CONDITIONS OF APPROVAL:

Engineering - PUD Plan Checklist

### Branch Creek Crossing Dev Plan Revision 3 Initial Submittal 12.11.2017.pdf

17. Existing Sewer

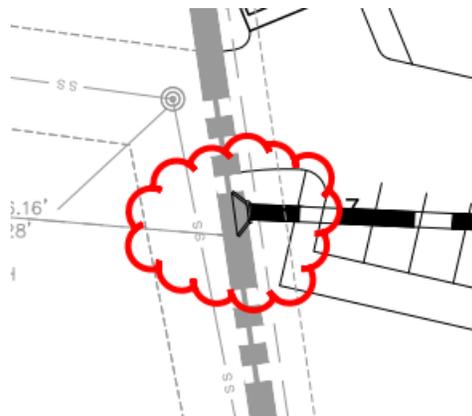
[jimmy.wiseman@franklntn.gov](mailto:jimmy.wiseman@franklntn.gov) The following comment shall remain open as a reminder for Staff. Additional design is needed at the Site Plan stage while alternatives are being discussed. Staff believes a desirable solution can be achieved.

*Applicant has stated that they have provided the top of casting for the existing sanitary sewer manholes. Unfortunately, the grade in this area is proposed to be raised with the completion of this project. If the final grade is to be raised and the fill puts the existing sanitary sewer at a depth greater than 12', the pipe material and easement shall be corrected to DI and the easement to 30' or the sewer shall be re-routed. No walls are permitted in the easement and it was stated by the applicant that the walls are required for the site to function. This has been discussed at numerous planning meetings with the applicant. The applicant shall provide a profile of the existing sanitary sewer main and the proposed final grade of the project. All possible conflicts with retaining walls, proposed utilities and easements shall be shown.*

### 33. Advisory Comment

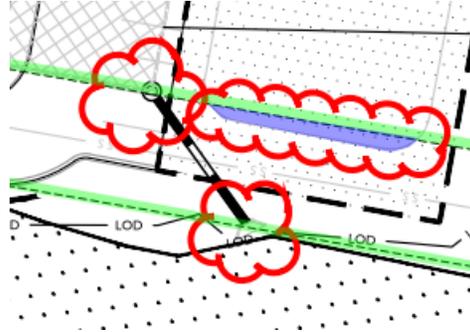
[joe.marlo@franklin.tn.gov](mailto:joe.marlo@franklin.tn.gov) The following is an Advisory Comment and **does not hinder approval of the Development Plan.**

Advisory Comment: During detailed engineering design at the Site Plan stage, Applicant shall locate all stormwater structures and BMPs outside of utility easements, including the sanitary sewer easement along the western edge of the site.

### 34. Advisory Comment

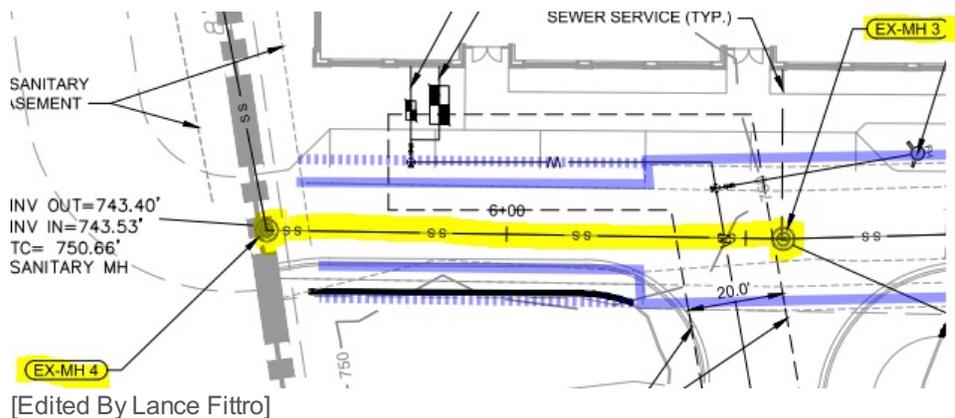
[joe.marlo@franklin.tn.gov](mailto:joe.marlo@franklin.tn.gov) The following is an Advisory Comment and **does not hinder approval of the Development Plan.**

Advisory Comment: If during detailed engineering design at the Site Plan stage, invert elevation depths of the existing sanitary sewer are determined to be 12 feet or greater below finish grade along any portion of the line, a 30-foot wide easement is required for that portion of the line extending from manhole to manhole, including the portion of line between EX-MH 3 and EX-MH 4. No walls or portions of walls (including footers or tie-backs) will be permitted in sanitary sewer easements.
